# P802.3bs optical reflection limits

IEEE P802.3bs Task Force, SMF Ad Hoc, May 2017

Comments [r01-19](#), [r01-45](#), [r01-52](#), and [r01-53](#) against IEEE P802.3bs D3.1 propose changing the extinction ratio specification for the optical PMDs to 3.5 dB

# LR4, LR8 0.6 dB penalty , 3.5 dB ER

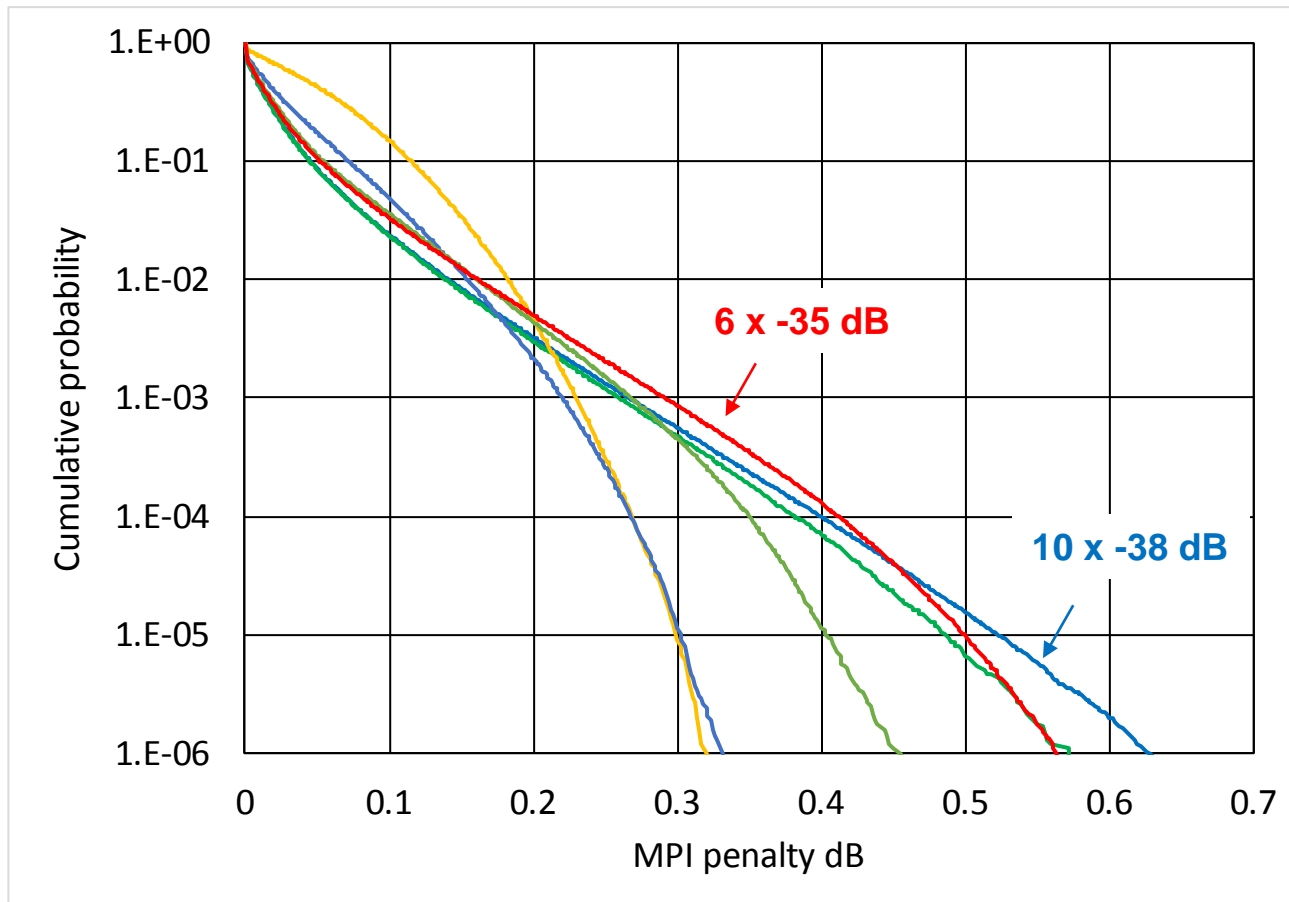
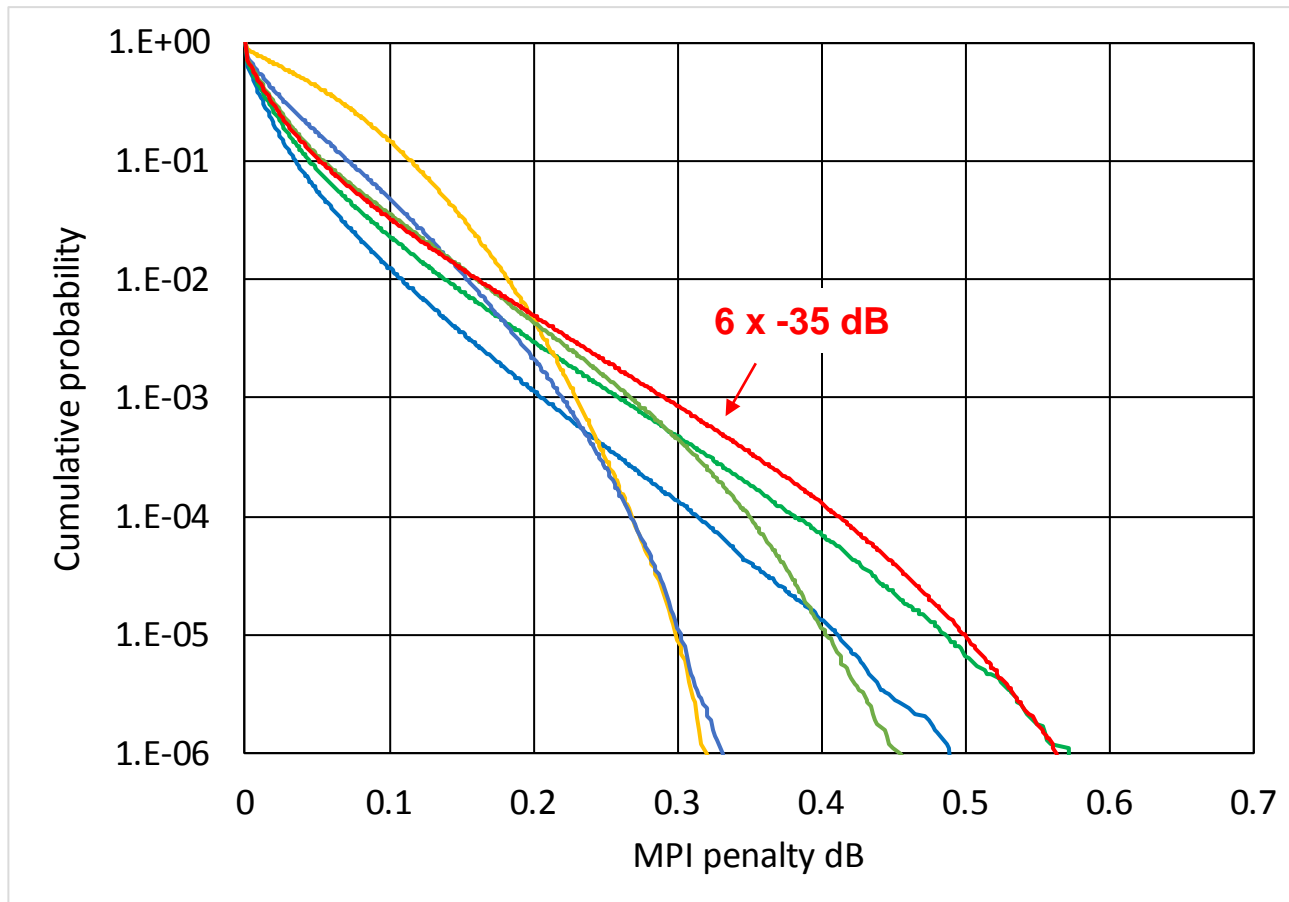
Changing the ER to 3.5 dB would require an increase of this allocation to about 0.6 dB if the ability to accommodate  $6 \times -35 \text{ dB} + 4 \times -55 \text{ dB}$  reflections is retained.

Proposals to make this change would have to include details of how the budget should be modified to accommodate the increased MPI penalty. If this is done, then the reflections given in Table 122-19 for 200GBASE-LR4 or 400GBASE-LR8 can still be supported with the exception that the value for 10 reflectances should be changed from -38 dB to -39 dB.

# FR4, FR8 0.4 dB penalty , 3.5 dB ER

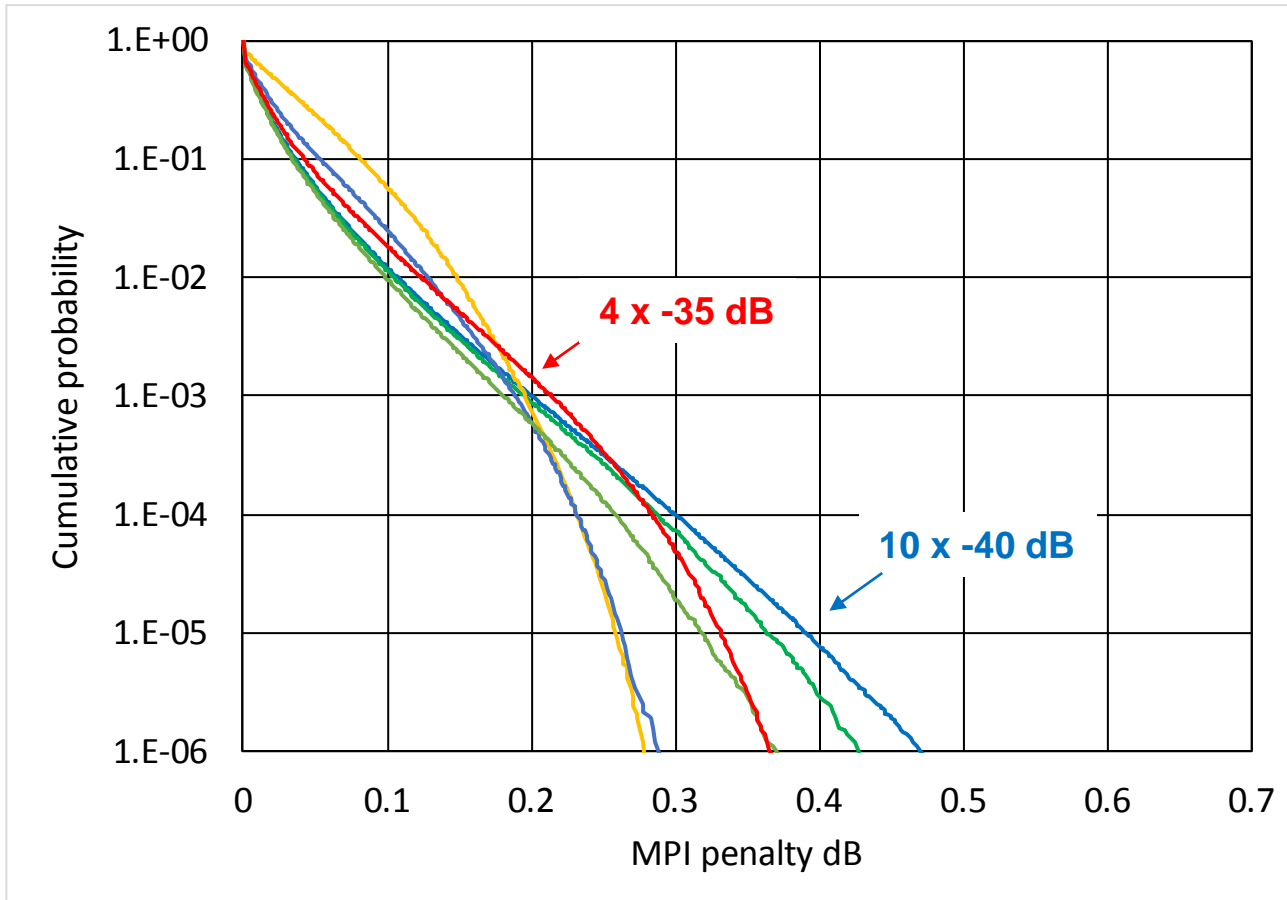
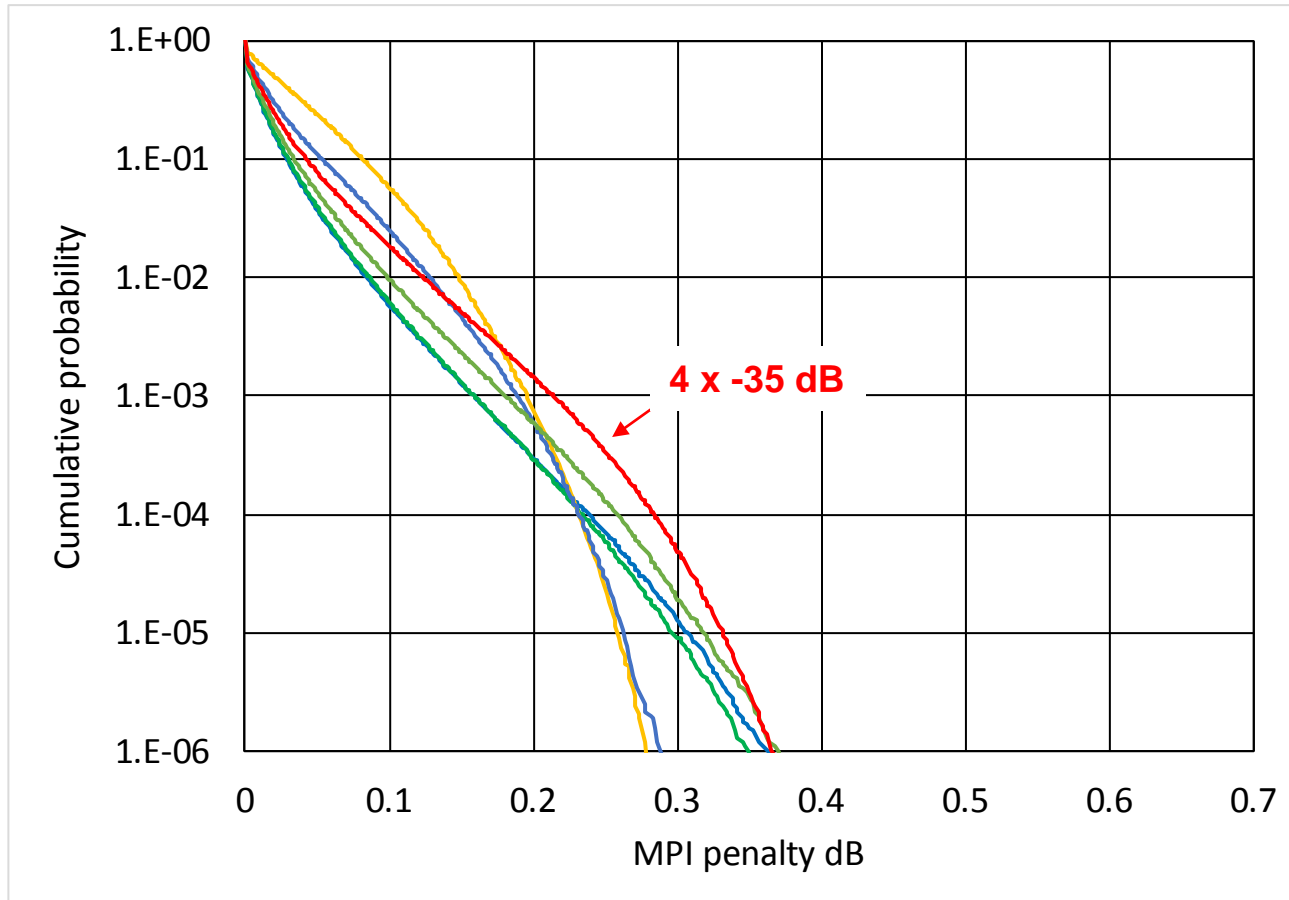
Changing the ER to 3.5 dB would require an increase of this allocation to about 0.4 dB if the ability to accommodate  $4 \times -35 \text{ dB} + 6 \times -55 \text{ dB}$  reflections is retained.

Proposals to make this change would have to include details of how the budget should be modified to accommodate the increased MPI penalty. If this is done, then the reflections given in Table 122-19 for 200GBASE-FR4 or 400GBASE-FR8 can still be supported with the exceptions that the value for 10 reflectances should be changed from -40 dB to -41 dB and the value for 8 reflectances should be changed from -39 dB to -40 dB.

# DR4, DR4 0.1 dB penalty, 3.5 dB ER

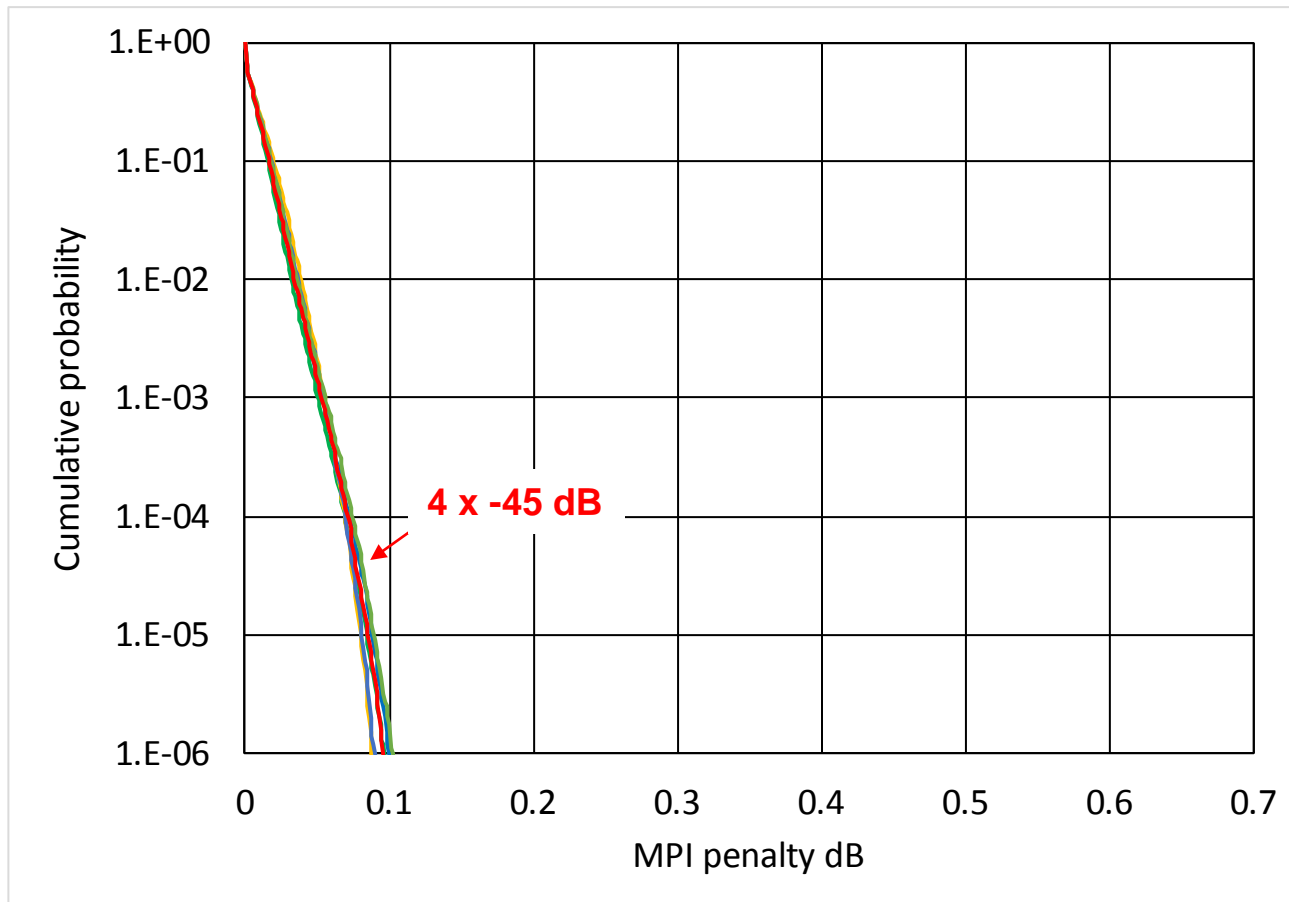
As can be seen from the previous slides, changing the ER to 3.5 dB would not require an increase of this allocation if the ability to accommodate  $4 \times -45 \text{ dB} + 6 \times -55 \text{ dB}$  reflections is retained.

Also, the reflections given in Table 121-15 for 200GBASE-DR4 or Table 124-13 for 400GBASE-DR4 can still be supported.
